ADDITION TO BAYSIDE BOWL
ALDER STREET
PORTLAND, MAINE

SHEET TITLE:
DETAILS

A5-8

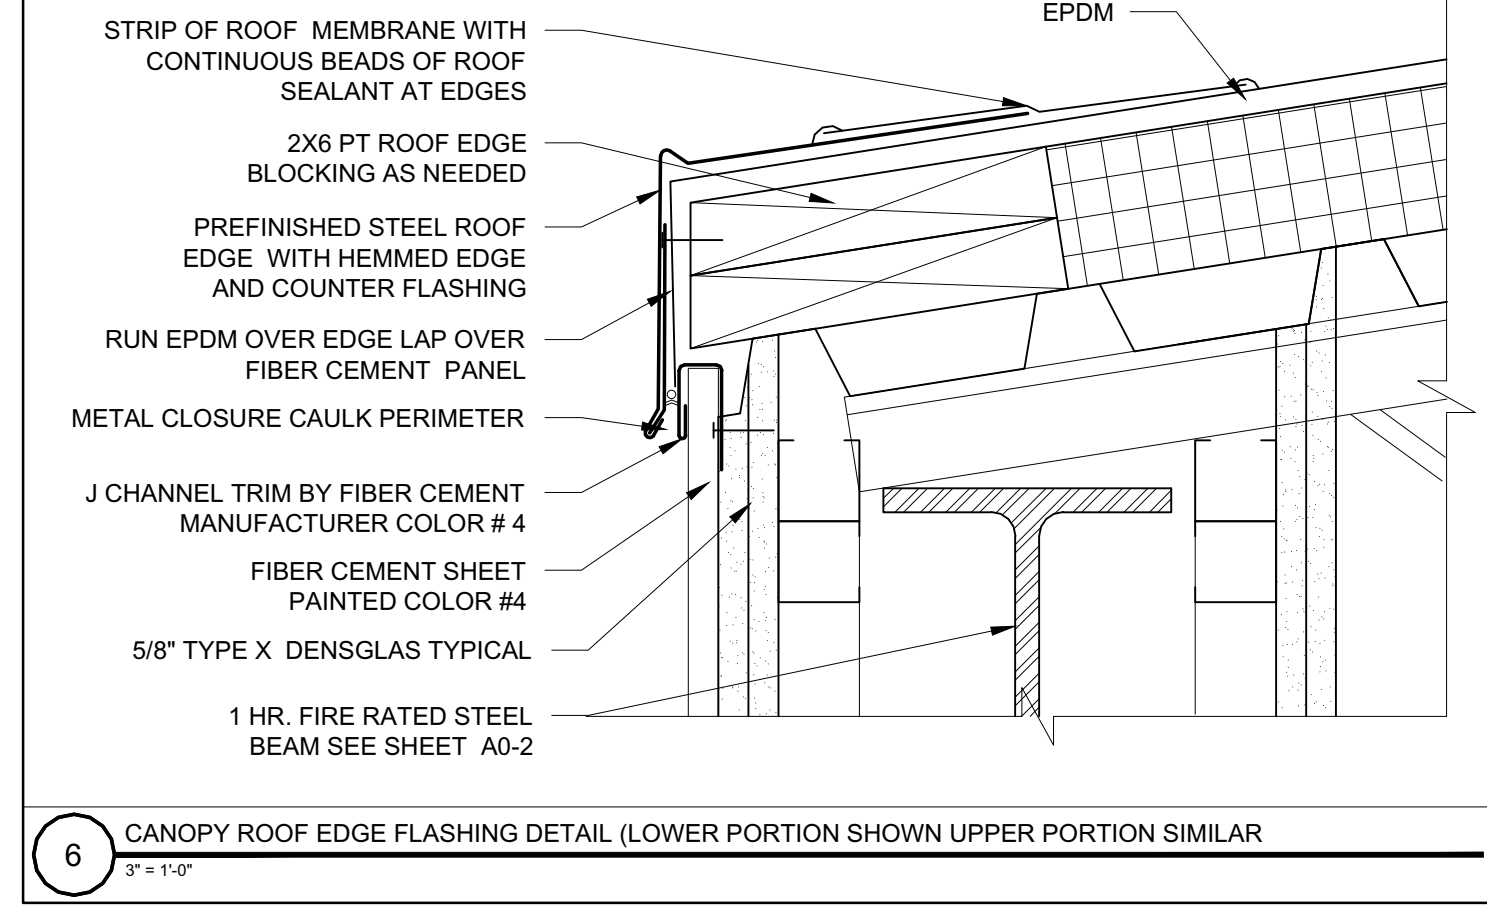
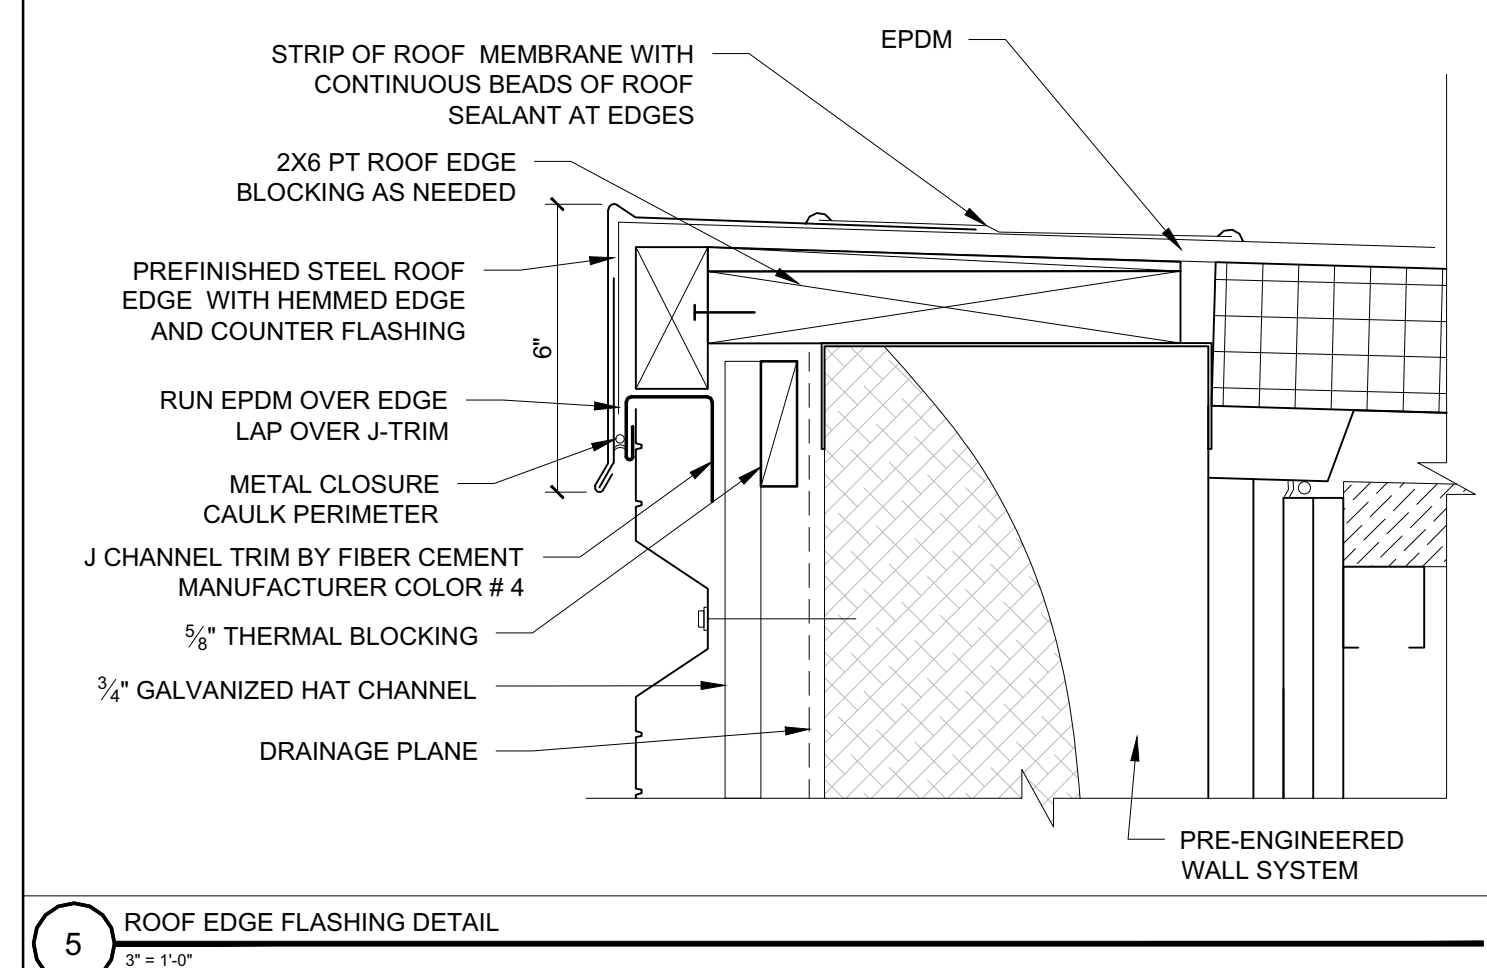
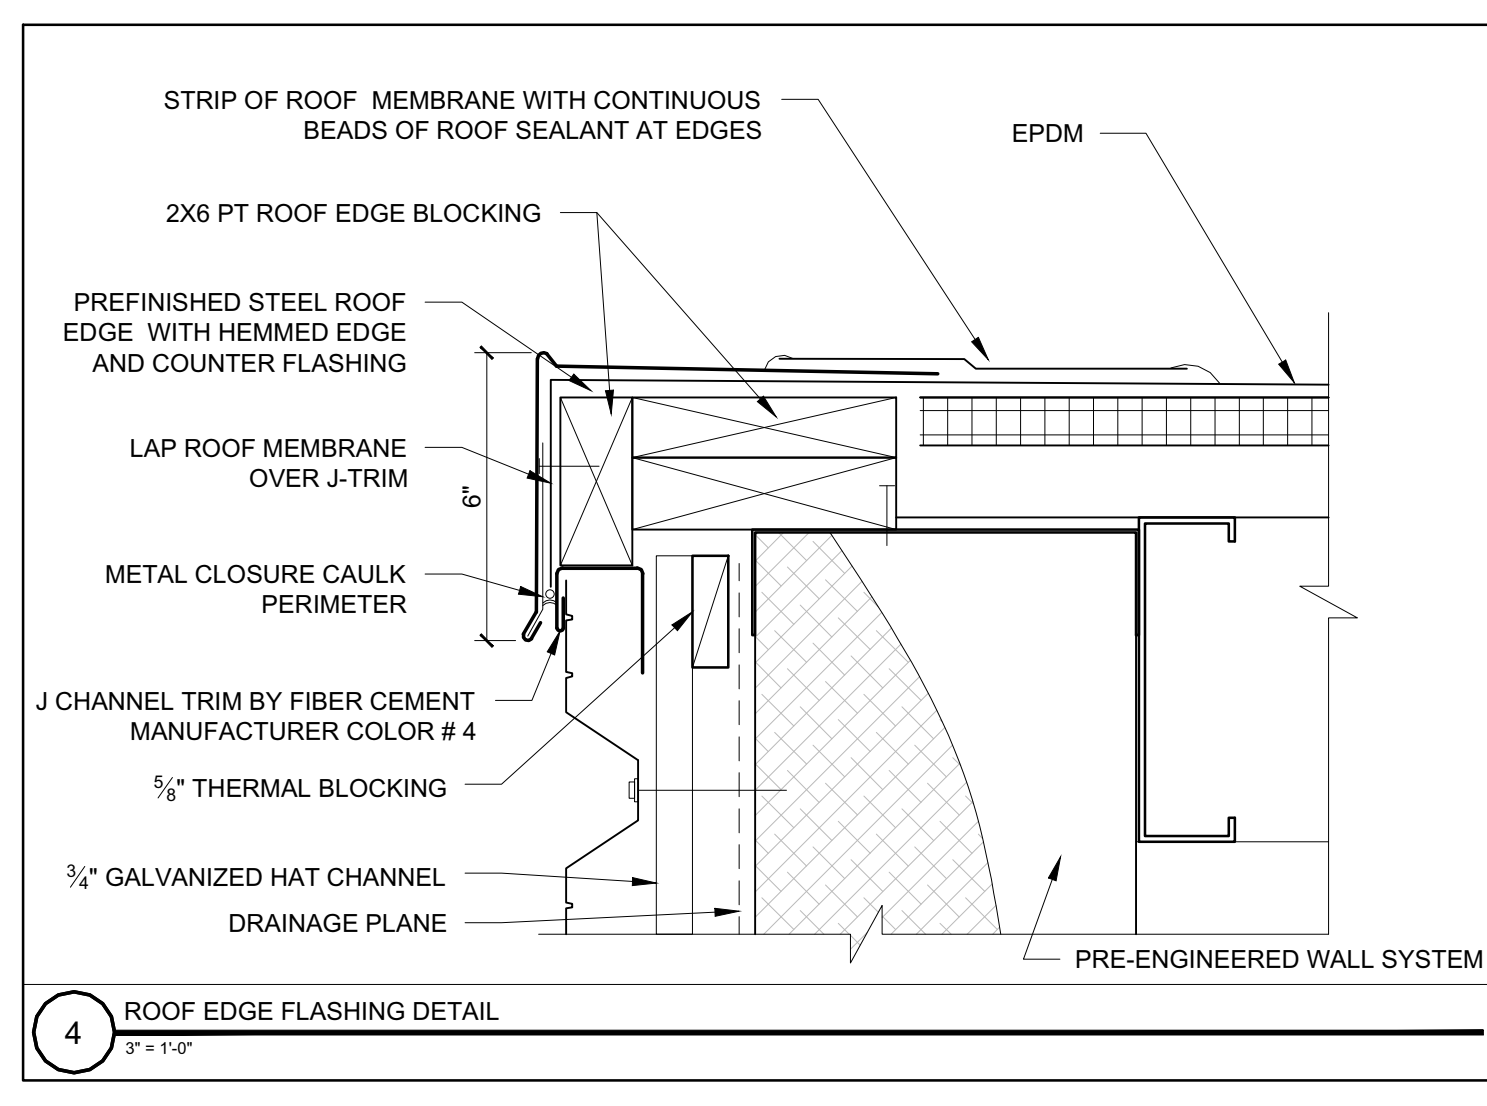
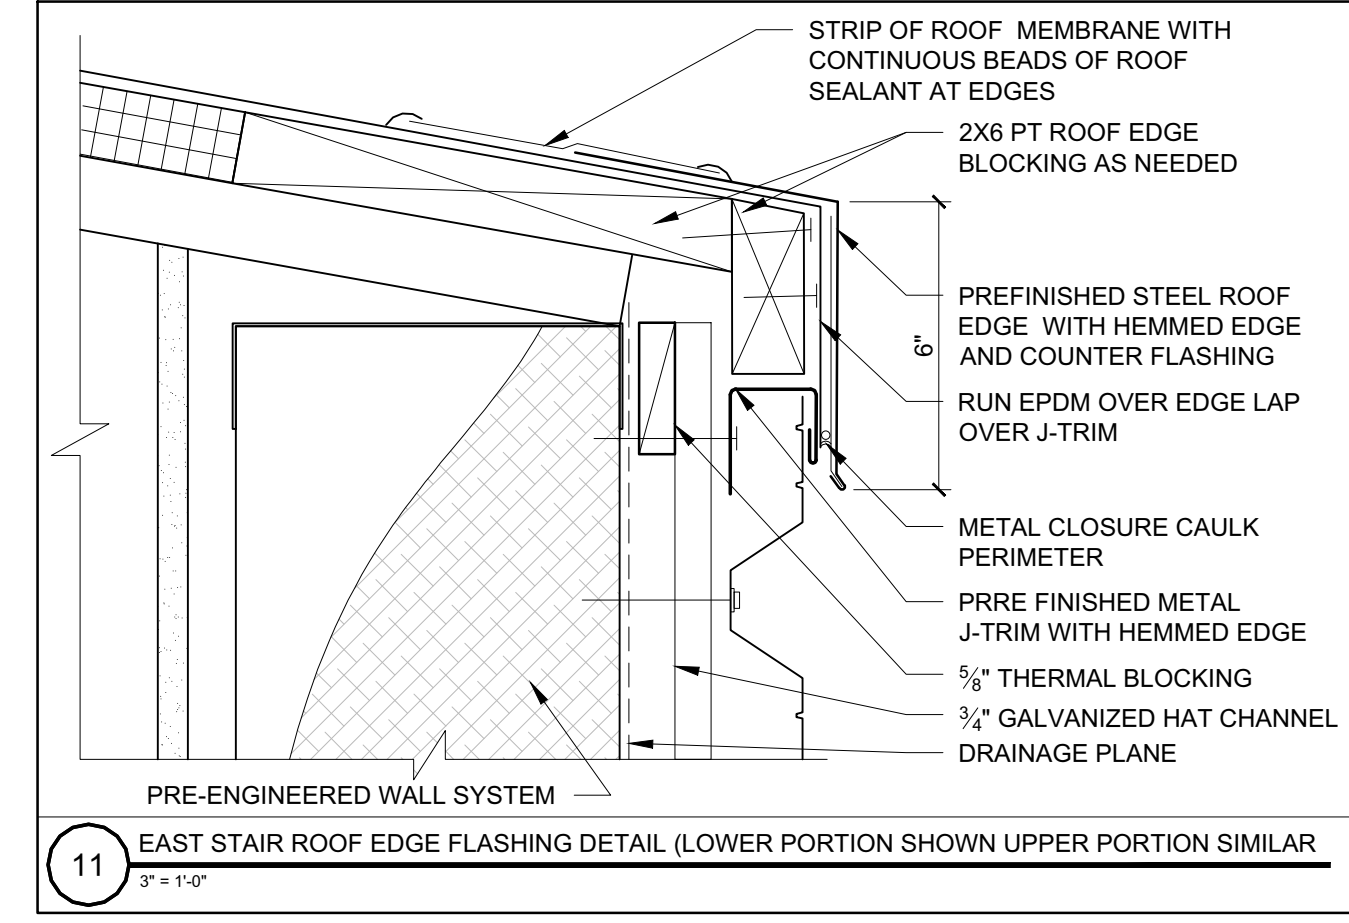
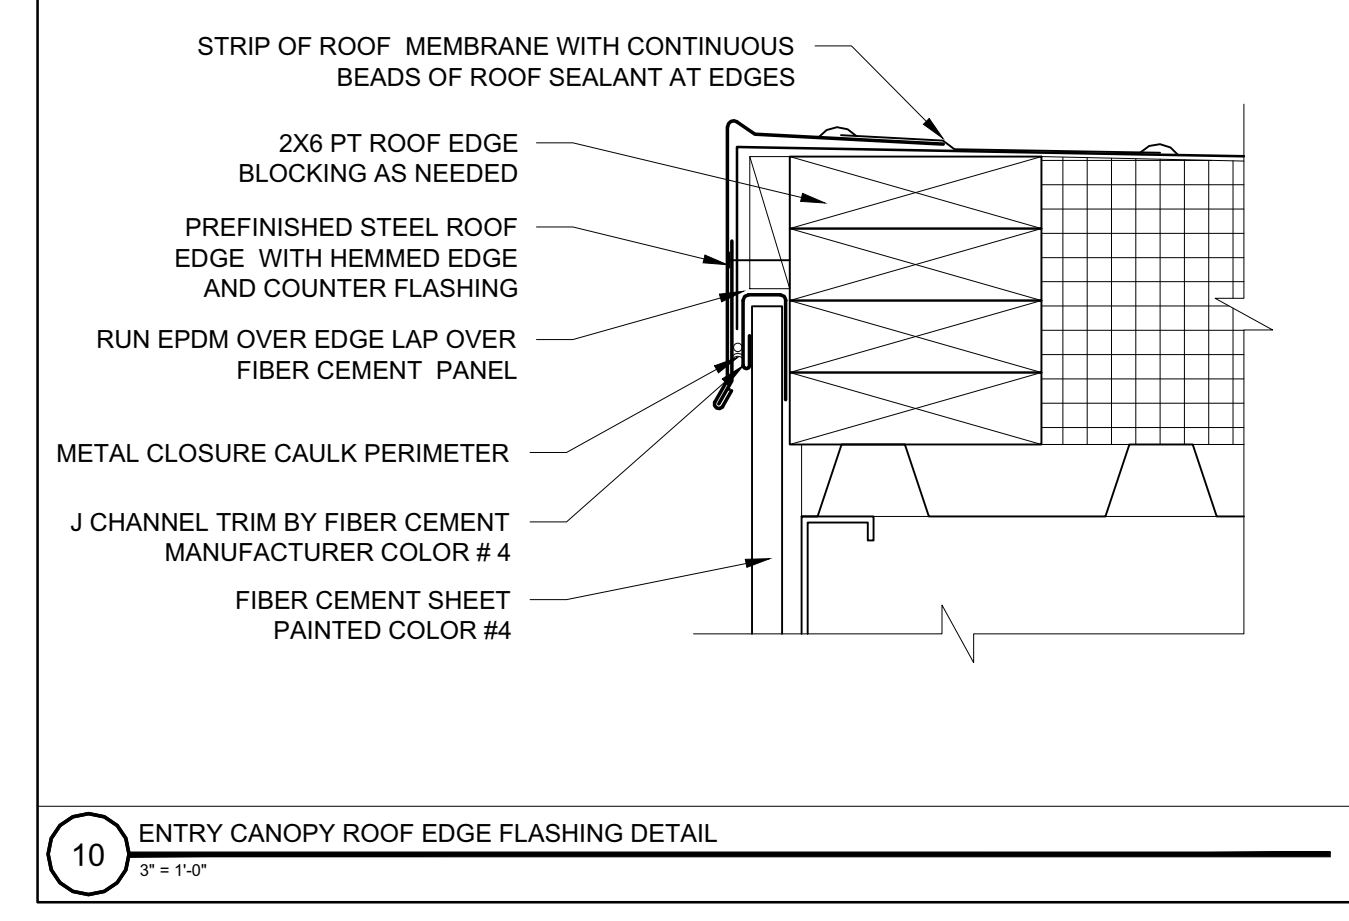
See Section 603. Building Type is a 2B. Reference 603.1.1. Clarify type of wood blocking per this section. The plans call of the roof edge blocking as PT not fire retardant. Review and revise.
